**PLANNING AND ZONING COMMISSION ACTION ITEM  
STAFF SUMMARY  
SEPTEMBER 12, 2022 PLANNING AND ZONING COMMISSION SPECIAL MEETING**

**A RESOLUTION RECOMMENDING THE APPROVAL OF AN  
APPLICATION FOR A CLASS S-2 SUBDIVISION TO BE KNOWN AS A  
RESUBDIVISION OF LOT 17, BLOCK B, NEW TOWN OF DILLON.**

**Figure 2. Lot Width Determination**

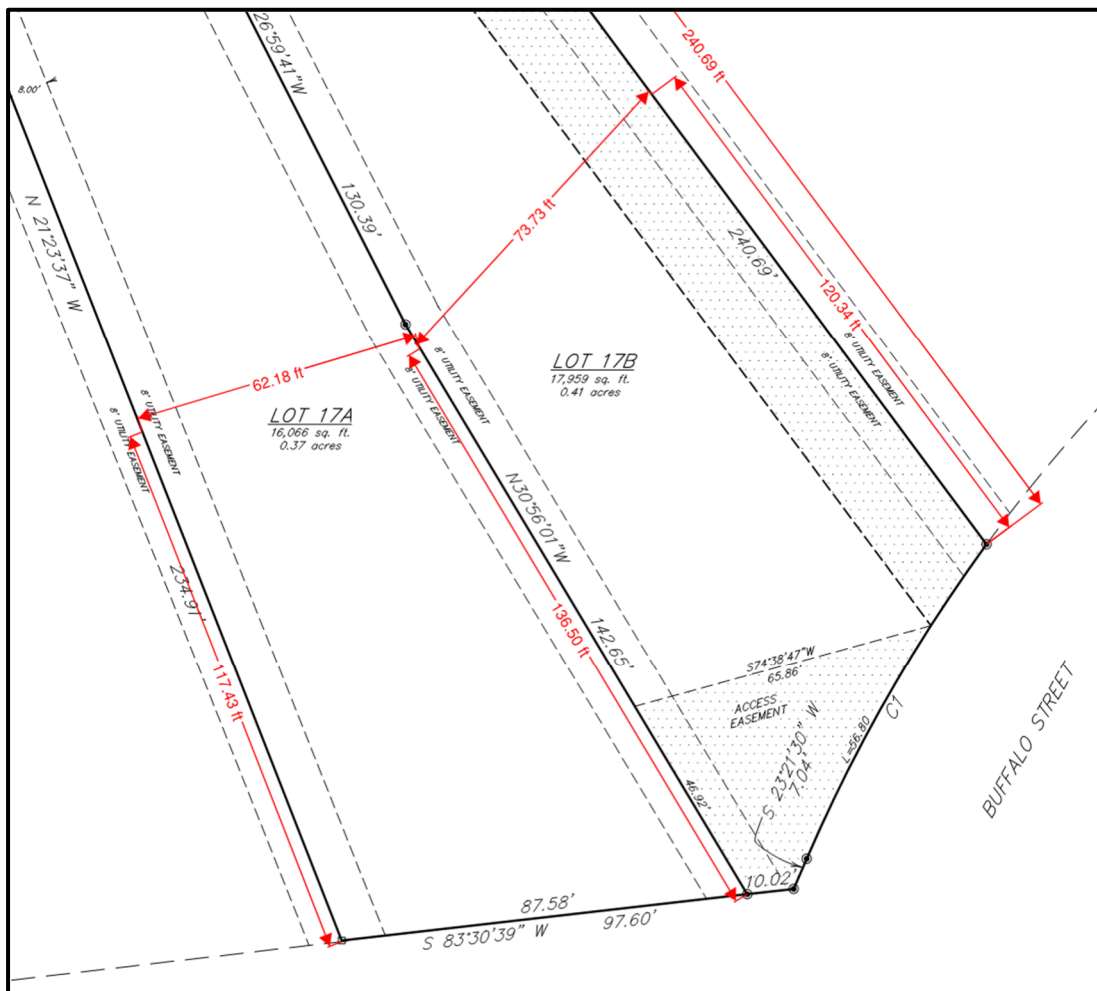
Lot Width = 60 feet and 65 feet for corner lots  
 Lot 17A: 62.2 feet and Lot 17B: 73.7 feet (Corner Lot) – meets Code  
 See **Figure 2**. For Lot Width Determination

**Exhibit 'A'**  
**Exhibit Map and Topography of Lot 17, Block B**  
**New Town of Dillon subdivision**

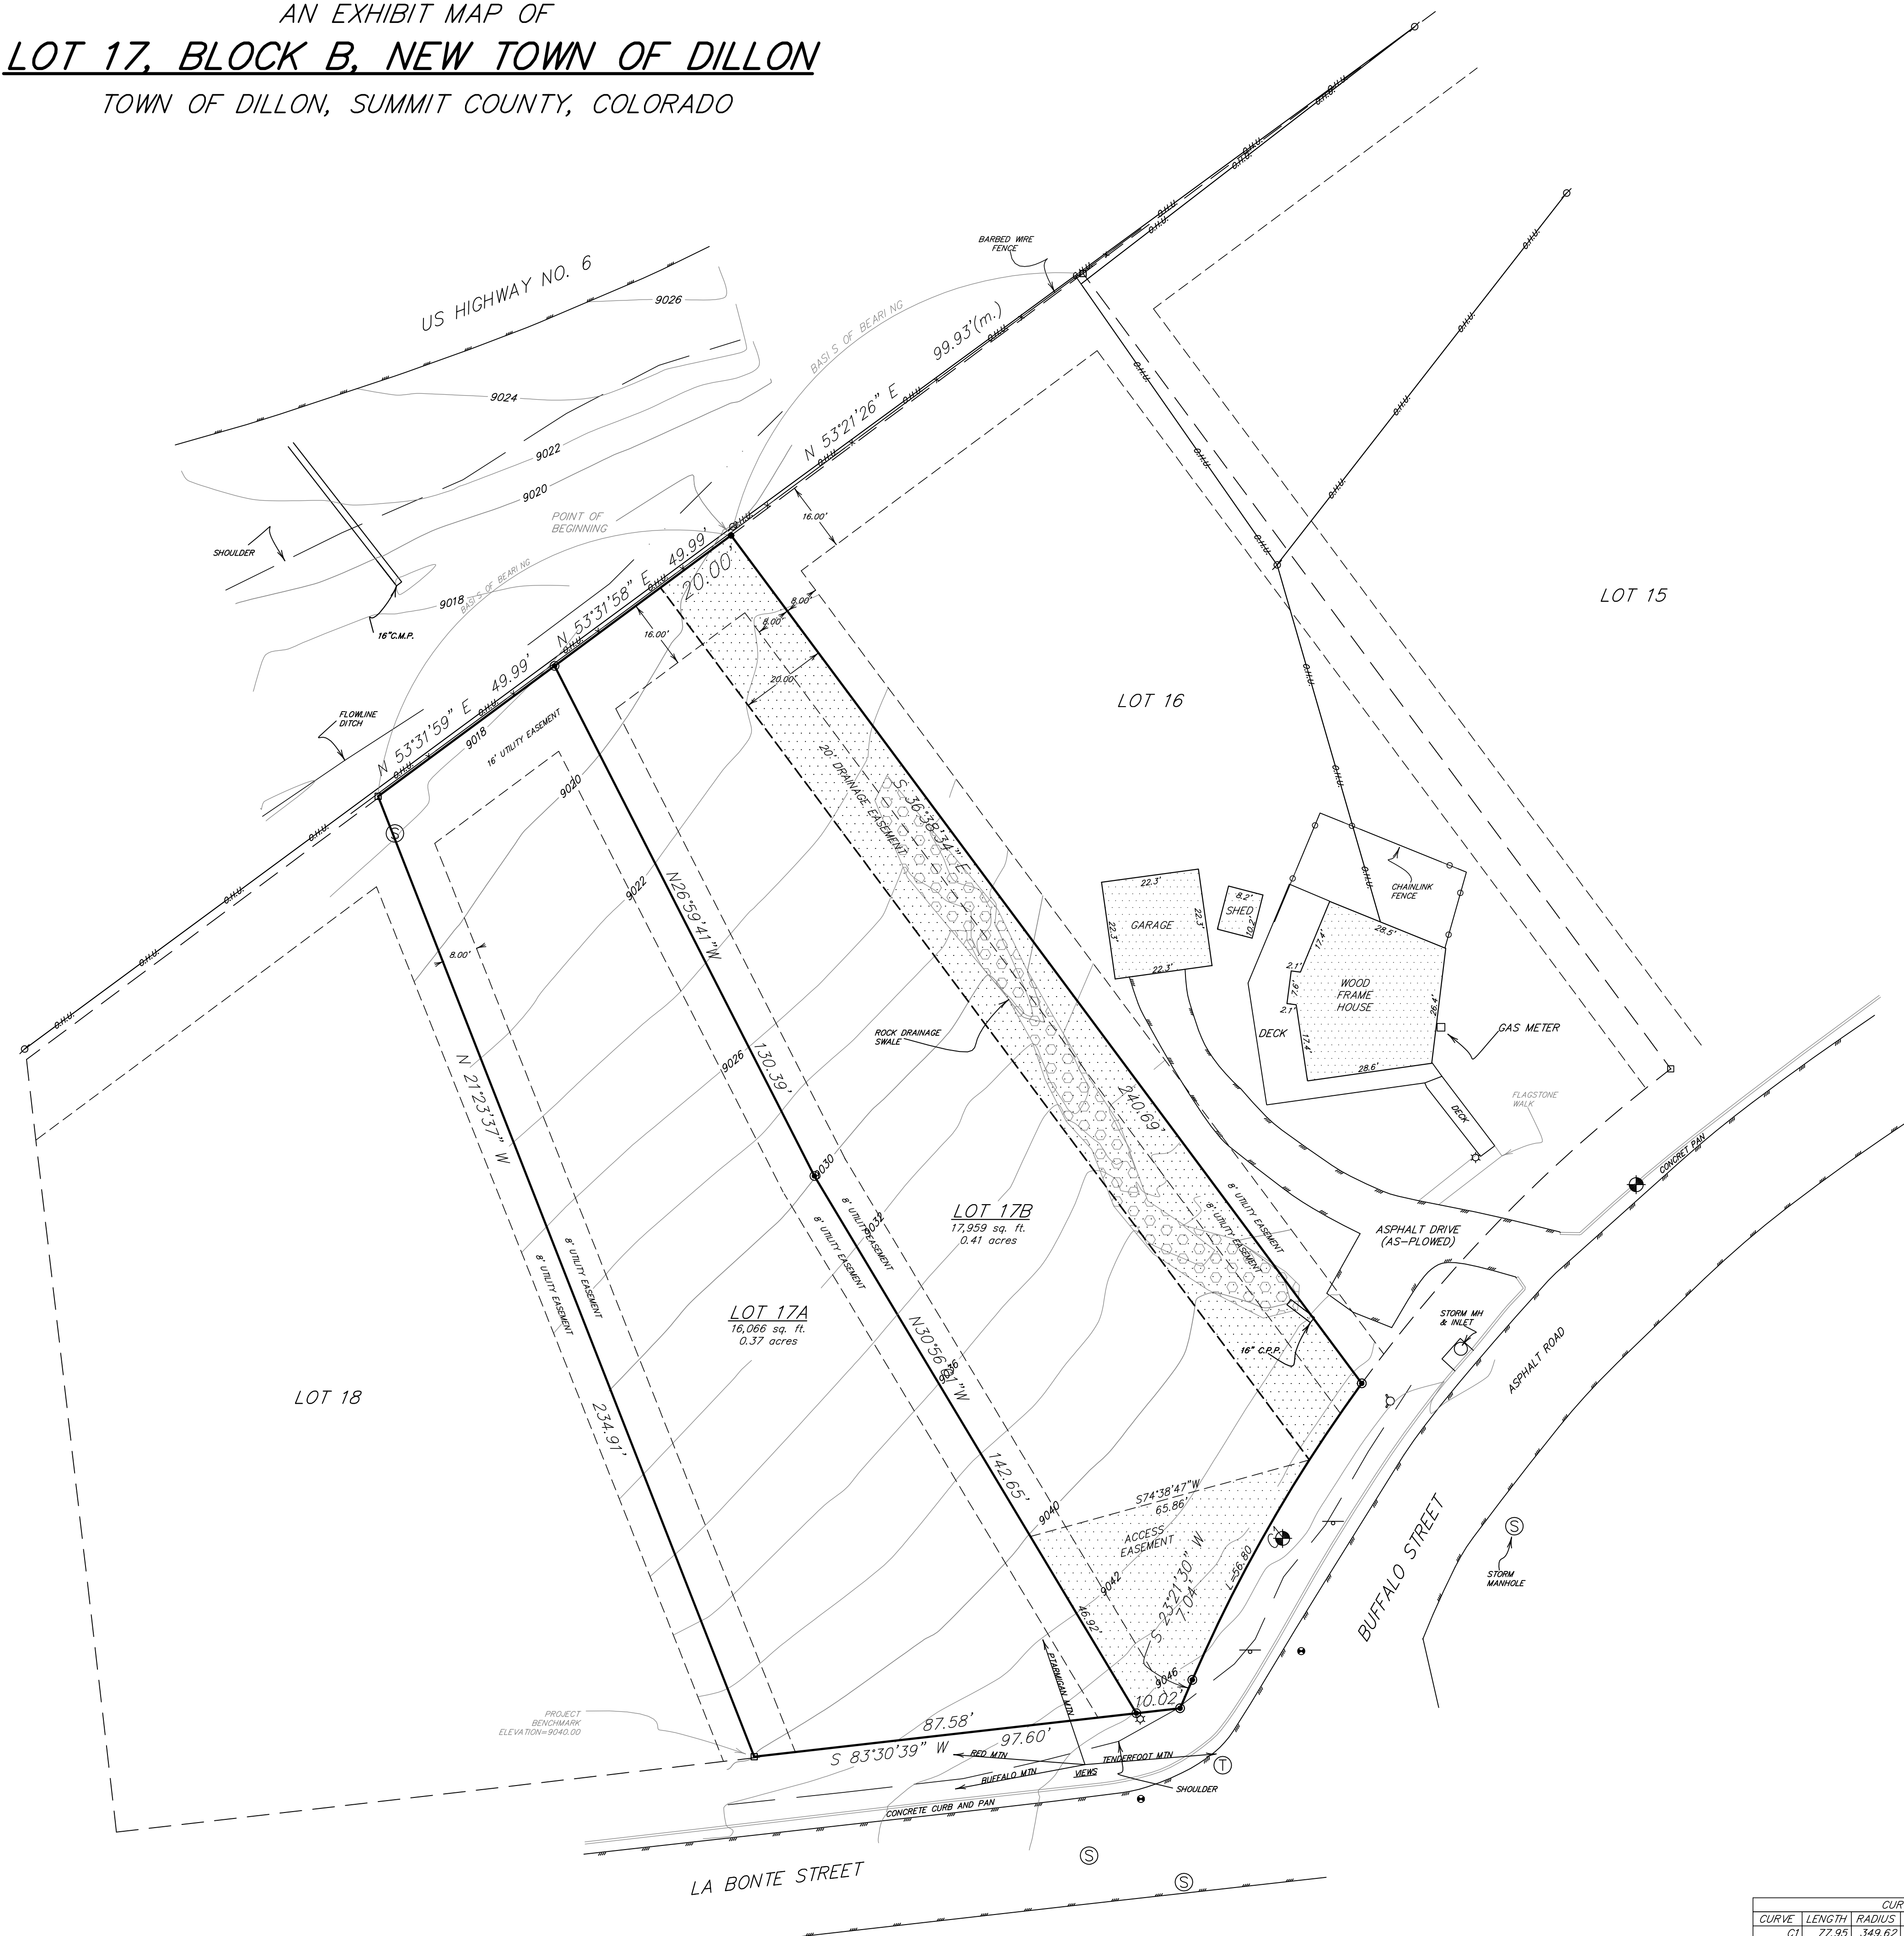
All lots shall abut a publicly dedicated street or alley or have access to a publicly dedicated street or alley through a permanently dedicated access easement adequate to serve the property with Town and emergency services. In cases where proposed lot design and layout results in marginal service to lots, the Town may deny the subdivision if deemed in the public interest. - *The driveway cut will be located on W. Buffalo Street with an Access Easement across Lot 17B for access to Lot 17A. The proposed driveway vicinity has been reviewed and approved by the Town Engineer.*

Lots shall be laid out so as to provide positive drainage away from all possible building sites; individual lot drainage shall be coordinated with the general storm drainage pattern for the area. Drainage shall be designed so as to avoid concentrations of storm drainage waters onto adjacent lots. All drainage courses shall be protected by covenants and deed restrictions preventing alteration, building upon or obstructing of the drainageways. – *The two created parcels will not cause concentrated drainage to shed onto a neighboring lot and future development on the parcels will not impact the existing natural drainage patterns nor existing downstream drainage areas. The existing 20’ Drainage Easement on the northeastern side of Lot 17B shall remain and continue to be utilized by the Town for stormwater drainage conveyance.*

by the unsuitable land conditions or development. Development, including the placement of public improvements and the creation of sites for the placement of structures, shall only be allowed on slopes in excess of fifteen percent (15%) if no other reasonable alternatives exist and the subdivider mitigates any potential negative impacts created by development on these slopes. In general no development should take place on slopes in excess of twenty percent (20%). – *The site has a general slop of 10.5% falling below the 15% threshold and no other site conditions exist that are deemed to limit the proposed subdivision.*

- A. *The Access Easement will be handled as conditioned in the Resolution recommending approval: “Within thirty (30) days of Applicant’s transfer of fee title to Lot 17A or Lot 17B, the Applicant and the new owner shall execute an easement agreement for the benefit of the owner of Lot 17A, granting such owner all rights of access over that certain portion of Lot 17B identified on the plat as “Private Access Easement for Lot 17A,” sufficient for the owner’s reasonable enjoyment of Lot 17A. The easement agreement shall address driveway maintenance responsibilities in a manner sufficient to prevent the driveway’s disrepair. The executed easement agreement shall be recorded with the Summit County Clerk and Recorder. The Applicant shall provide the Town with a copy of the executed and recorded easement agreement within ten (10) days of its execution.”*
